# TDEC and stressed OMA consistency in 100GBASE-SR4

IEEE P802.3bm, September 2014, Ottawa

# Changes to the draft - illustrated

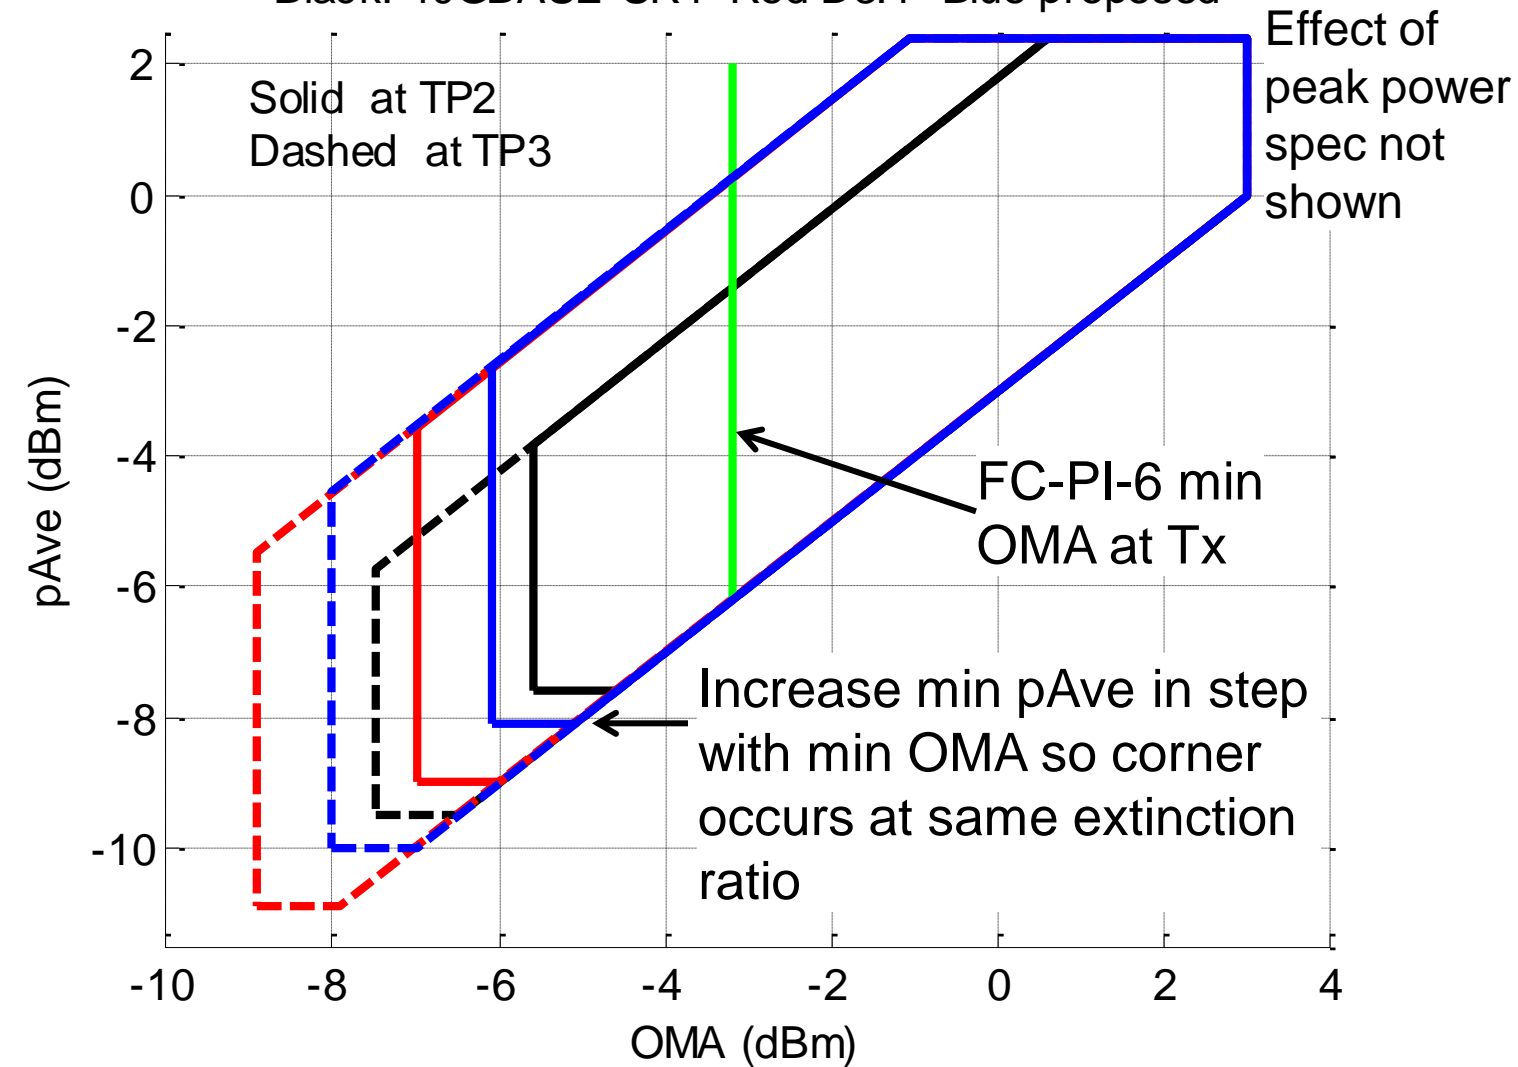
Black: 40GBASE-SR4 Red D3.2 Blue proposed

- Effect of reducing the max Tx TDEC by 0.4 dB
- Thin lines on the left show the TDP or TDEC of a fast noiseless signal without jitter or emphasis
- Transmitters with less than 1.4 dB TDEC have more emphasis than back-to-back penalty. We don't need to outlaw them but we should not give any such transmitters of the future an OMA credit
